# Wisconsin Department of Transportation

### NOTICE TO ALL CONTRACTORS:

**Proposal #02: 5990-00-34**  
**C Janesville, W Milwaukee Street**  
**Rock River Bridge B-53-0294**  
**Local Street**  
**Rock County**

This is Addendum No. 01, which provides for the following:

GENERAL PLAN		SHEET 1 OF 32	
		156

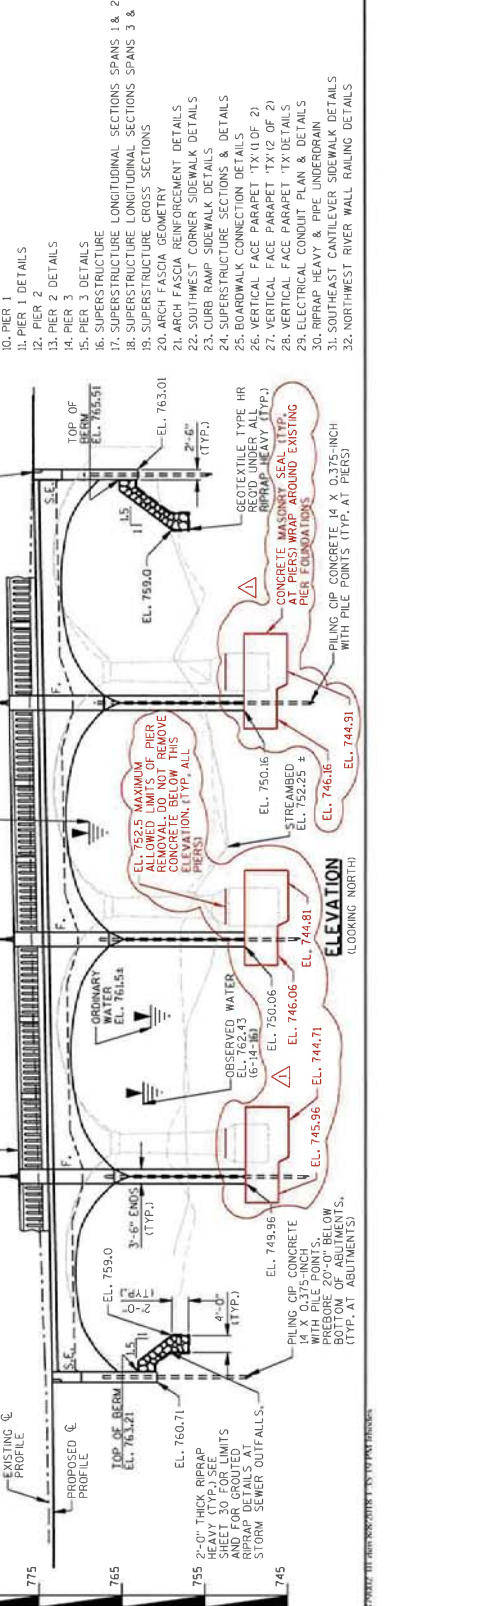
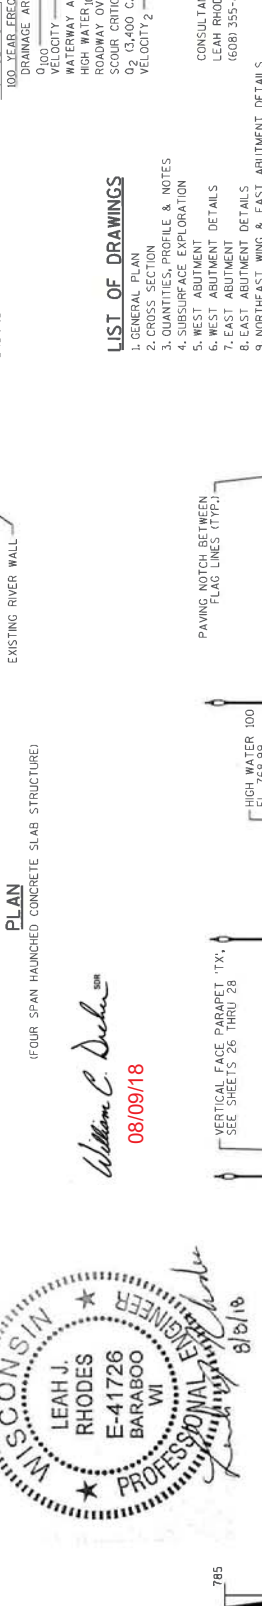
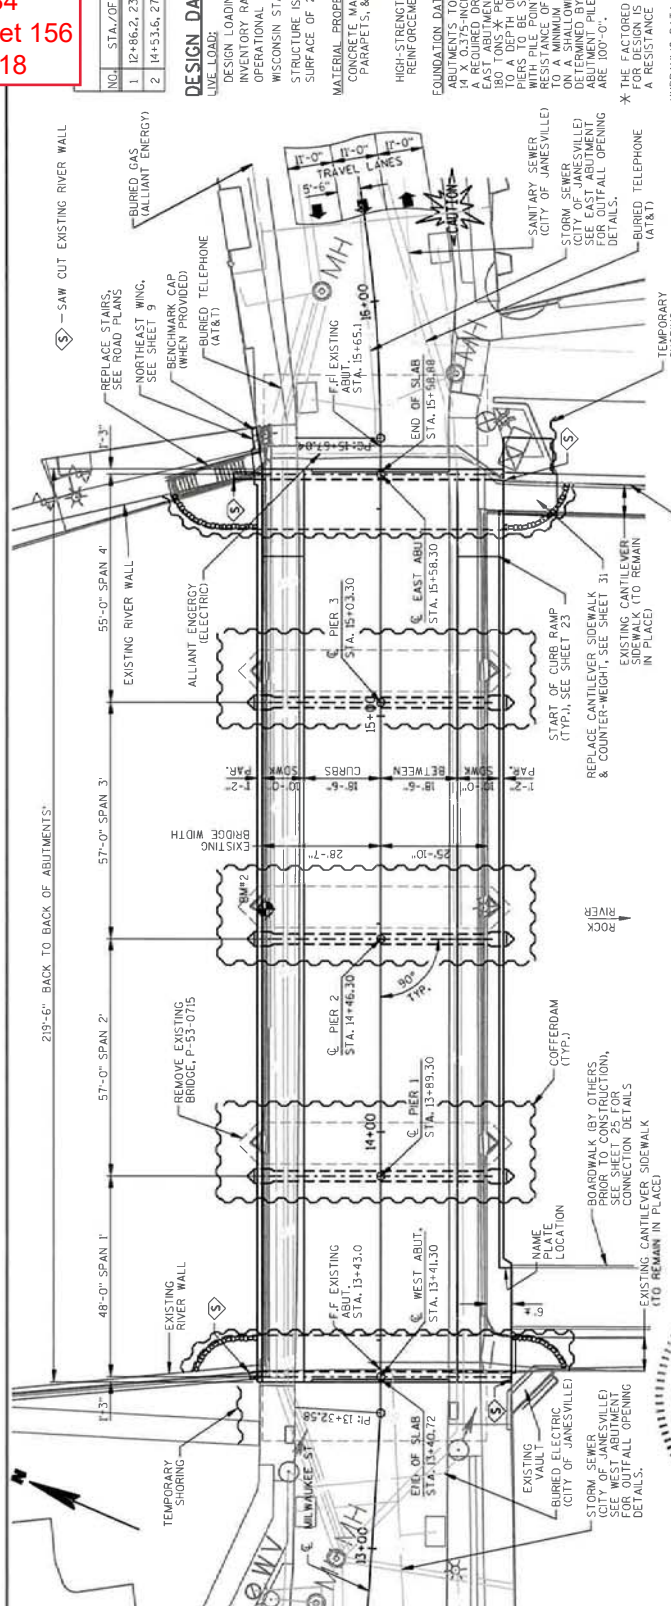
Revised Plan Sheets	
Plan Sheet	Plan Sheet Title (brief description of changes to sheet)
156	General Plan (Added Concrete Masonry Seal details)
157	Cross Section (Added Concrete Masonry Seal details)

NO.	DATE	REVISION	BY
1		ADDED CONCRETE SEAL	RLR

**AT THE PIERS, COFFERDAMS SHALL BE DEWATERED BEFORE PLACING PIER CONCRETE. THE CONCRETE MASONRY SEAL WAS DESIGNED FOR THE 2-YEAR HIGH WATER ELEVATION OF 762.27.**

QUANTITIES, PROFILE & NOTES  
 SHEET 3 OF 32  
 158

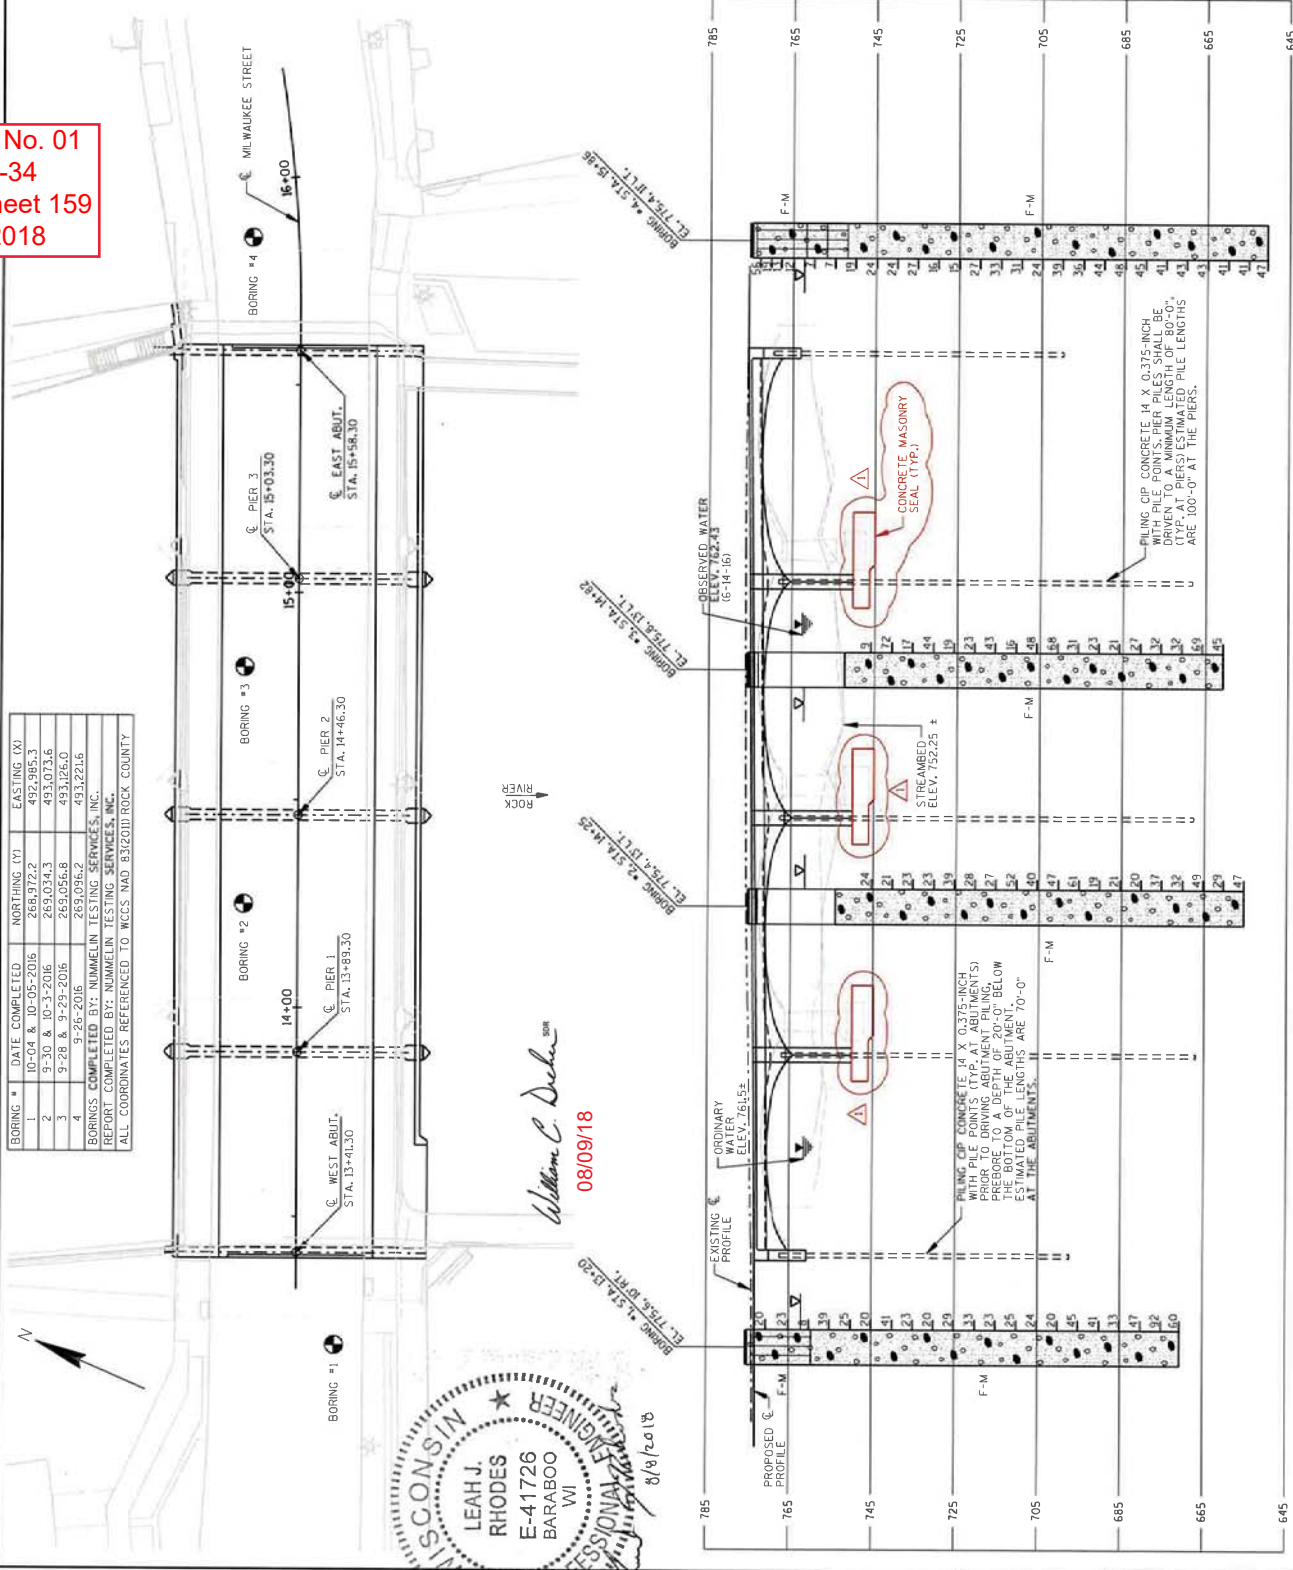
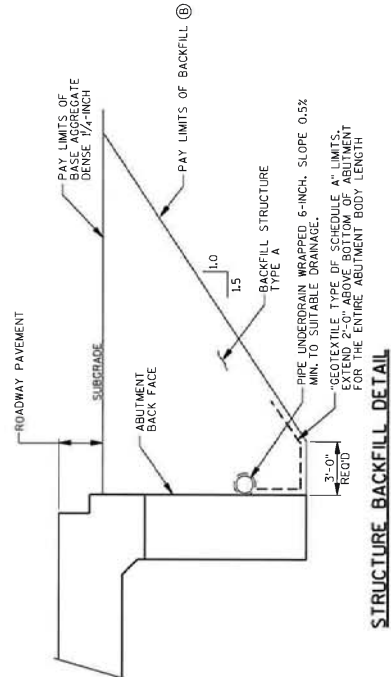
158	Quantities, Profile & Notes (Updated quantity table to add Concrete Masonry Seal bid item; revised piling and bar steel quantities at the piers)
159	Subsurface Investigation (Added Concrete Masonry Seal details)
165	Pier 1 (Added Concrete Masonry Seal details; modified piling and bar steel)
166	Pier 1 Details (Added Concrete Masonry Seal details; modified bill of bars)
167	Pier 2 (Added Concrete Masonry Seal details; modified piling and bar steel)
168	Pier 2 Details (Added Concrete Masonry Seal details; modified bill of bars)
169	Pier 3 (Added Concrete Masonry Seal details; modified piling and bar steel)
170	Pier 3 Details (Added Concrete Masonry Seal details; modified bill of bars)
